Planning proposal PP-2022-1898 to amend Bankstown Local Environmental Plan 2015

Planning proposal (Department Ref: PP-2022-1898): to amend Bankstown LEP to enable the staged redevelopment of the Bankstown Central Shopping Centre site through increased building height and floor space ratio (FSR) controls.

**RE: PLANNING PROPOSAL FOR 'BANKSTOWN CENTRAL SHOPPING CENTRE
("Vicinity")' – BANKSTOWN LOCAL ENVIRONMENTAL PLAN (BLEP) 2015**

**Reference: PLANNING PROPOSAL FOR 'BANKSTOWN CENTRAL SHOPPING CENTRE' –
BANKSTOWN LOCAL ENVIRONMENTAL PLAN (BLEP) 2015 – RESPONSE TO
TFNSW LETTER DATED 18 MAY 2022**

Figure 2.2: Daily Traffic Profile at Macauley Street

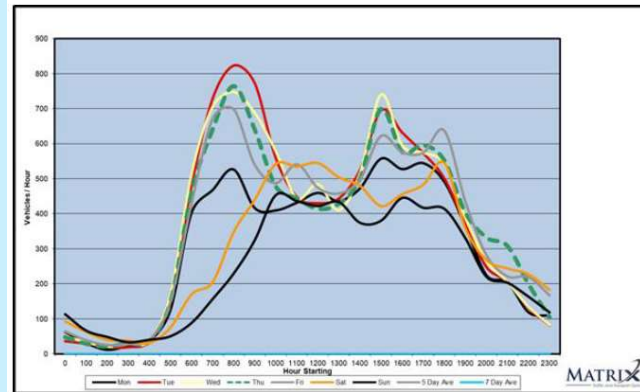
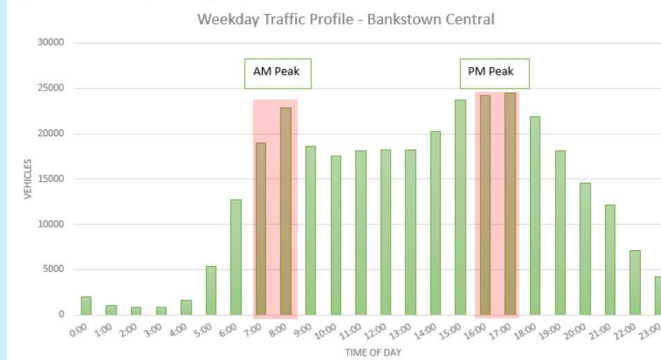
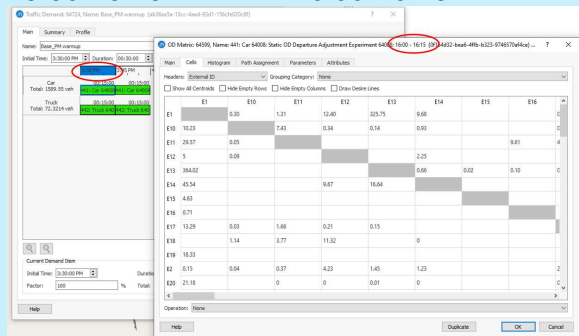
The daily profile at Macauley Street shows that the PM peak at 3pm during the weekday does not align with the PM peak hour identified through all the sites (total) 4-5pm. This implies that the traffic movement has different trip pattern dependent on the origination / destination within the study area.

Figure 1: Proposed Jacobs Street Extension and Bus Interchange – Concept Design

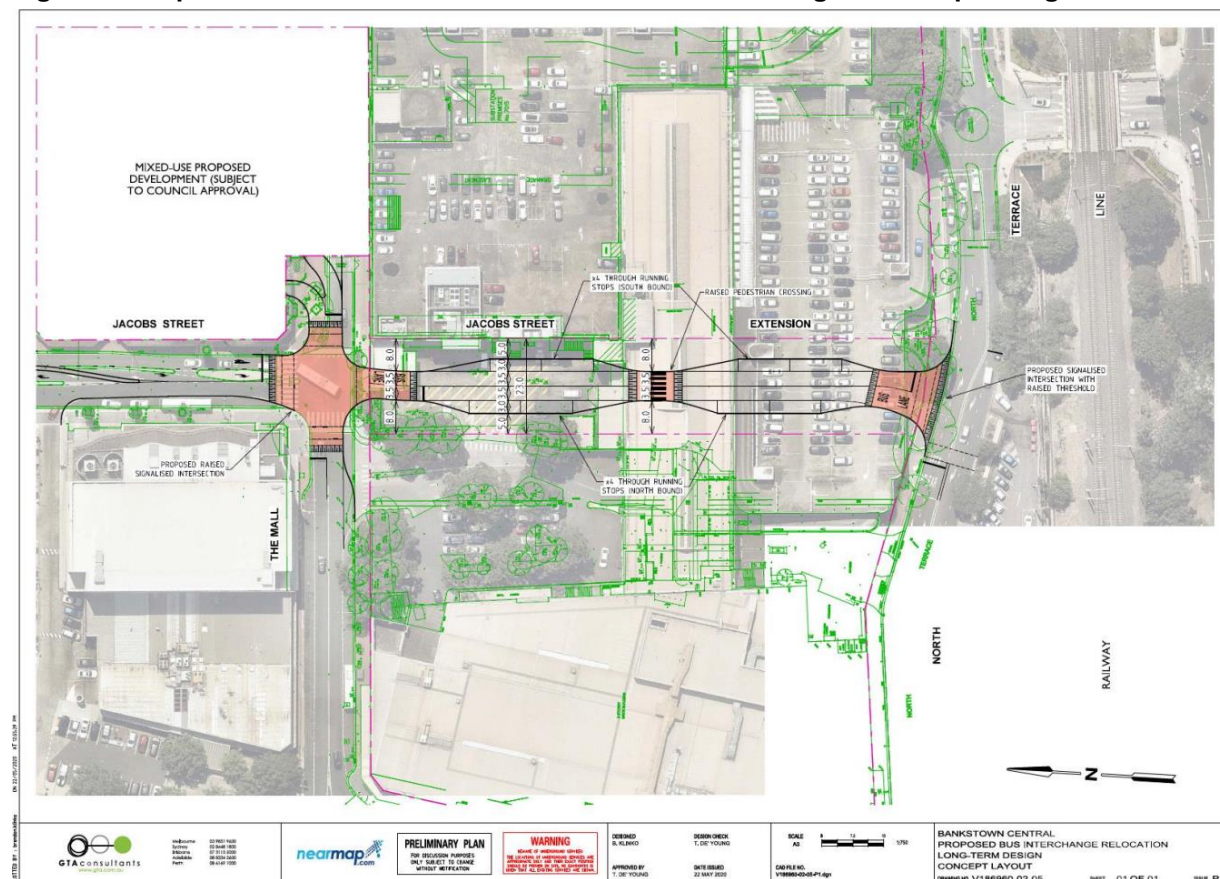
TfNSW understands that the location and arrangement of the proposed bus interchange facilities are yet to be finalised, as such further review will be undertaken by TfNSW at later stage once final arrangement of the bus interchange facilities are completed. If required, TfNSW is willing to facilitate a meeting with the proponent and Council to discuss this matter in further detail.

Specifically, the TIA includes a concept layout plan for the on-street bus interchange with the provision of 8 on-street bus bays. This concept layout is reproduced below in Figure 1 for reference. It is noted that the provision of 8 bus stops is consistent with the arrangements recently approved by Council and TfNSW for the relocation of the existing bus interchange off the Bankstown Central site. The relocation will see two bus stops provided on Bankstown Central land (together with 10 layover bays), two bus stops located on Jacobs Street north of The Mall, and four bus stops located on The Mall west of Jacobs Street. This arrangement is anticipated up to the delivery of the long-term solution.

Figure 1: Journey to Work Mode Share (ABS Census Data, 2016)

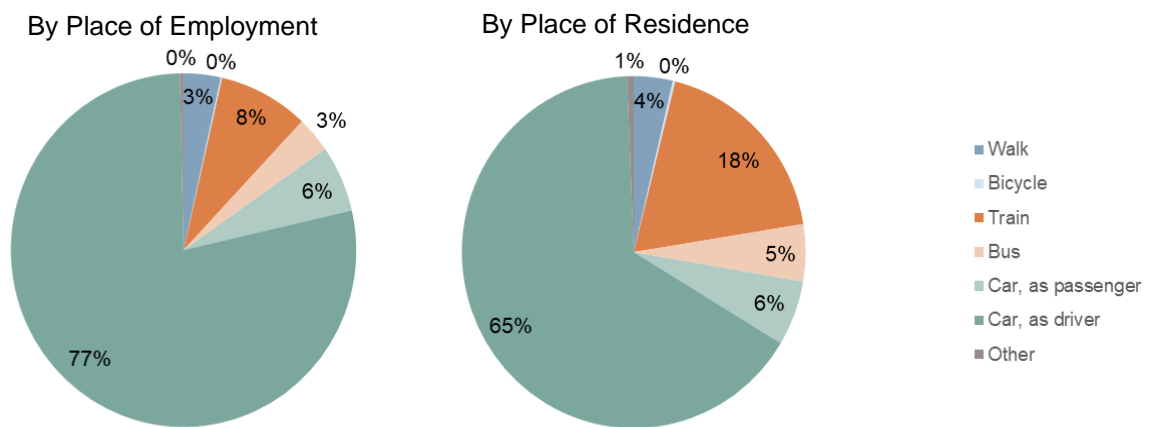
Section/Page ref	Comment/suggestion
Section 3.2 (Page 19)	The report assumes a high proportion of public transport usage for the proposed development. This should be compared with the current mode share data for the area. The current capacity of bus and rail services serving Bankstown area should also be analysed to understand if the current public transport have the capacity to accommodate the proposed future public transport usage as indicated in the report. This may require specific measures to improve such public transport usage proposed for the development as well as preparation of a Travel Demand Management Plan and Green Travel Plan.
Section 3.3 (Page 20)	The person-based trip estimation should include estimation of trips for AM peak. The trip generation estimation should include trips generated from all proposed development, including additional retail and childcare facilities.
Section 4 (Walking and Cycling)	The proposal and associated traffic assessment should include any future proposal of Bankstown Metro Station and proposed active transport linkages specially on the northern side of the proposed metro station.

ABS 2016 mode split data for Bankstown as both an origin and destination for work-based trips is summarised in Figure 1.

Figure 7.3 (Future Base with Complete Streets)

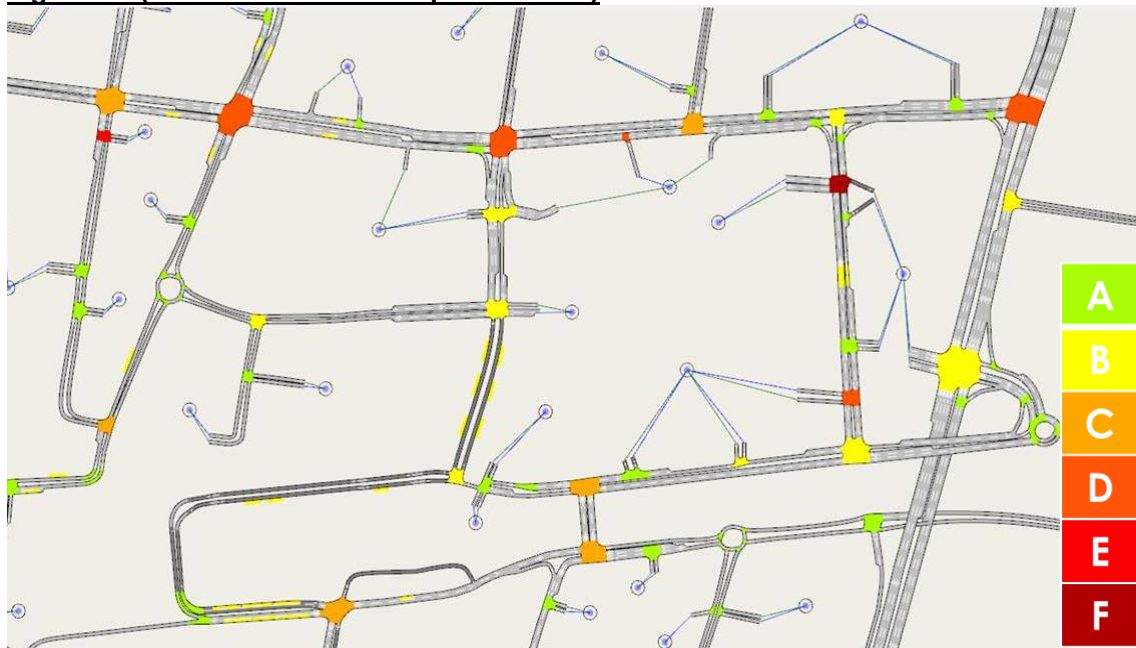
Section/Page ref	Comment/suggestion
	The report should also include a figure showing adopted trip distribution percentages for the proposed development.
Figure 7.3 and Figure 7.4	Please include map key to show color coding for different LoS.

The figures were included in the TIA report to simply show that there was no material change expected in the Level of Service at key intersections. For reference, Figure 7.3 (Future Base with Complete Streets) and Figure 7.4 (Post Development with Complete Streets) are reproduced below with a legend.
